# PROJECT SUMMARY

New Commercial Gym (5,000 sq.ft.) and 13 Townhouse Units in two buildings.

## PROJECT ADDRESS

Sheet: Solid Waste / Refuse

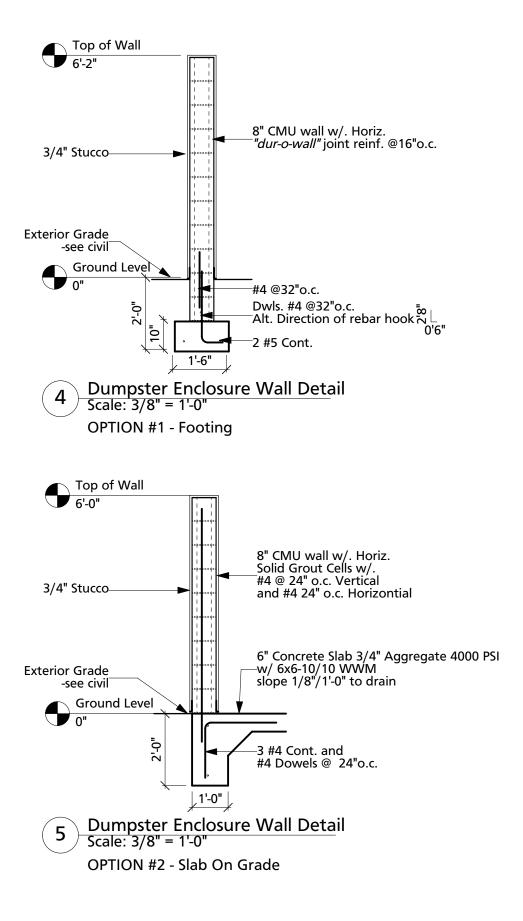
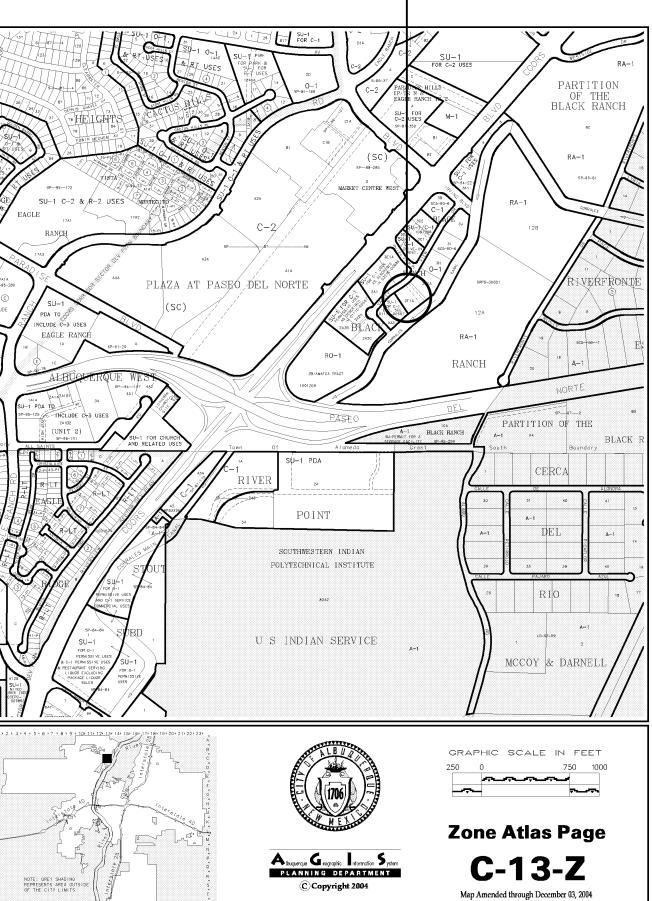
Approved for access by the Solid Waste Department for a double trash enclosure Herman Gallegos 05-12-22 Herman Gallegos

PRE POUR INSPECTION REQUIRED BY COA SOLID WASTE DEPARTMENT
